Service Advisory

CC-555A

Subject: Service Replacement Hydro Transmissions 759-04144 & 759-04145

759-04144 Service Kit Contents

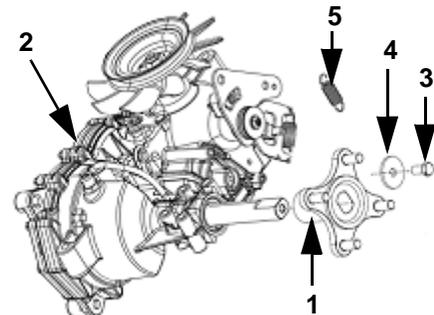
These Service Kits will replace the LH & RH hydro transmission part numbers 618-04164, 618-04164A, 618-04327 & 618-04163, 618-04163A, 618-04326 when stock is depleted. The replacement transmission has a Double-D axle which requires a Double-D wheel hub assembly. The LH Transmission Service Kit 759-04144 & the RH Transmission Service Kit 759-04145 will include the items shown below.

ITEM NO.	PART NUMBER	QTY	DESCRIPTION
1	618-04317	1	HUB ASM: WHL:DOUBLE-D LONG
2	618-04431B	1	TRANS ASM: HYDRO:EZT:LH
3	710-3119	1	SCREW:3/8"-16 x .750:GR5:LOCK
4	736-0227	1	WASHER:FLAT: .390 x 1.50 x .134
5	732-04448	1	SPRING:EXTENSION (See page 2)
